Technical Service Bulletin

57 Door cannot be opened from outside handle in cold weather

57 12 63 2020051/4 March 15, 2012. Supersedes Technical Service Bulletin Group 57 number 11 – 44 dated February 16, 2011 for reasons listed below.

Model(s)	Year	VIN Range	Vehicle-Specific Equipment
Audi Q7	2007 – 2010	All	Not Applicable

Figure 2. Bowden cable (1), and door handle mounting bracket (2).

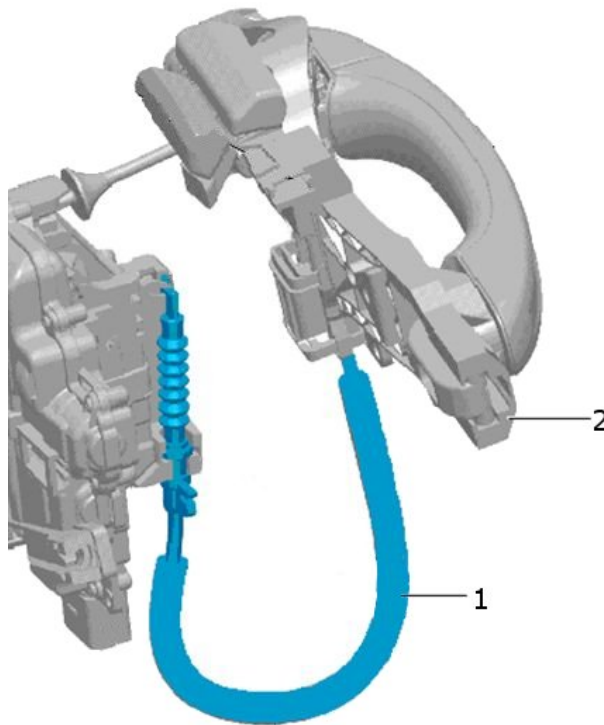
1. Obtain a new exterior door handle bearing bracket assembly, which includes the Bowden cable.

The part number revision has not changed for the reworked parts. Improved parts will eventually be introduced with a new part number revision.

Figure 5. Location to apply Bowden cable fabric (red).

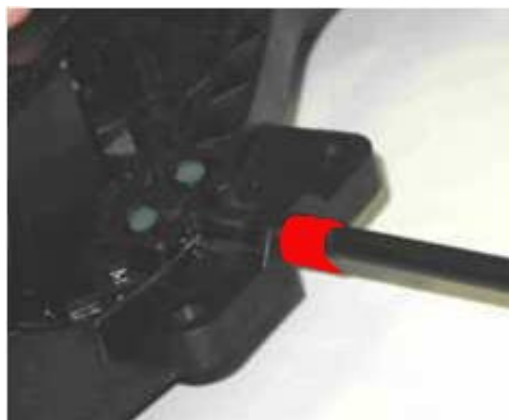
- b. Apply a protective fabric strip around the Bowden cable where it touches the bearing bracket.
